THIRD ANGLE PROJECTION	UNITS: mm	SCALE: 1/1	SHEET: 1/1	MODEL NO.: COMMON
	MATERIAL: SEE NOTES		TREATMENT: SEE NOTES	
DSGD by: Killy	2025/08/8	PART NAME: MODEL LABEL		
APVD by:		PART NO.:3MD539LB010		VER.1
APVD NO.: M3231	FILE NAME: 3MD539LB010.cdr	DIVA Laboratories,Ltd.

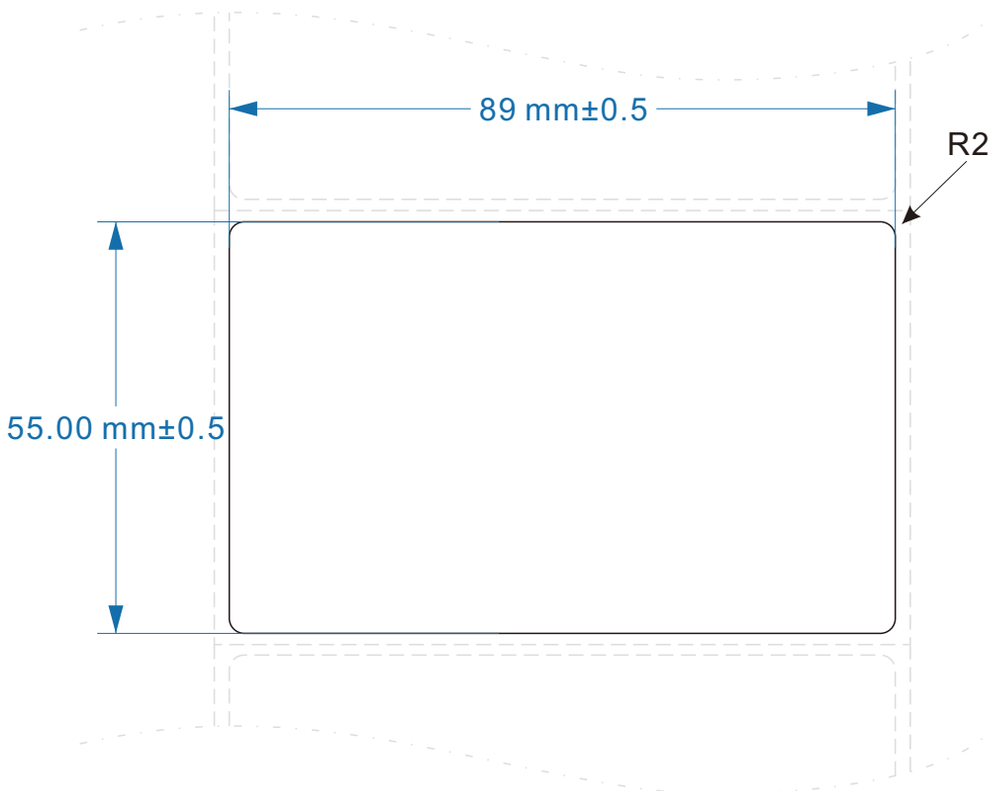
REV.	DATE	DESCRIPTION	BY	APVD
1	20250808	修正原公差0.2mm變0.5mm(小於0.2需使用雷射刀模費)	Killy
